Letter to the Editor

Comments on a Case Study on Engineering Failure Analysis of Link Chain

Fig. 1. Schematic of link chain stresses and fracture locations.

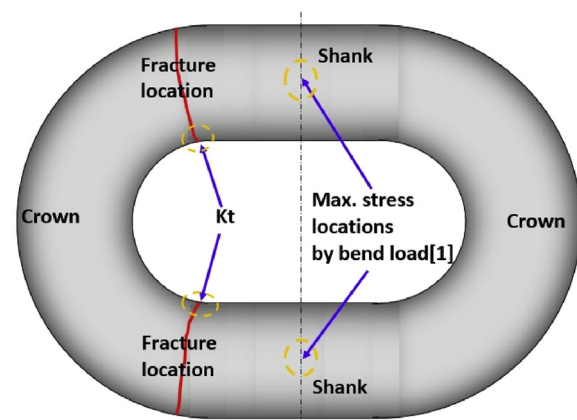
The chain fractured at the locations where the crown and shank intersected, as shown in Fig. 1, based on Fig.2 of the article [1]. Radical patterns arrowing to the chain inner surface (intrados) was observed on L/H fracture surface (Fig.3 of the article) [1], suggesting that crack likely initiated around the chain inner surface, where presence of high tensile stress under tension load [5,6] but very low stresses under bending load (Fig.11 of the article) while a so called “crushed damage” area was found there, indicating “crushed damage” could not be formed by the compressive load which the article claimed. The article did not conduct necessary detail examination on “crushed damage” area to determine its nature, it looked like an impact damage after the chain fracture.

Kt and crown top are max. stress locations by tension load [5][6]

As observed in fractographic analysis, there was significant plastic deformation (chain narrowing), suggesting that the chain was fractured by overload. Chain narrowing was in-plane deformation, mainly caused by in-plane loads such as tension while the bending load was out-of-plane load but no out-of-plane deformation was observed on the chain. The chain fractured at the locations where the crown and shank intersected. Coincidentally, the maximum stress of the chain under tension located there (Kt-intrados where crown and shank intersected) [5,6], while the stresses at fracture locations under bending load were very low but the maximum stresses under bending were located on upper surfaces in the middle of shanks (Fig.11 of the article [1] and Fig. 1).

Fig. 2. Stress distribution of link chain under tension load [5].

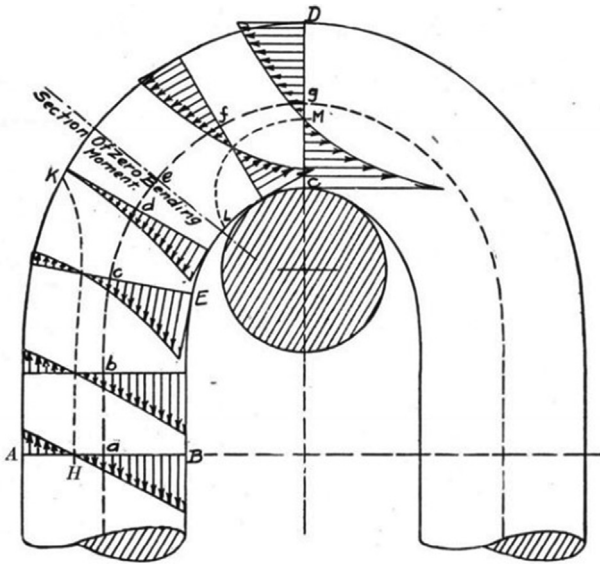
topographies” (only ~30 microns per step) as microscopic features under high magnifications cannot be taken as characteristic for bending moment fracture. Furthermore, bending moment and tension in chain were not contrary, both sides of the chain were subject to bending moment and tensile force when it was loaded by tension, as shown in Fig. 2 [5], i.e. no real uniaxial tension in link chain loading.
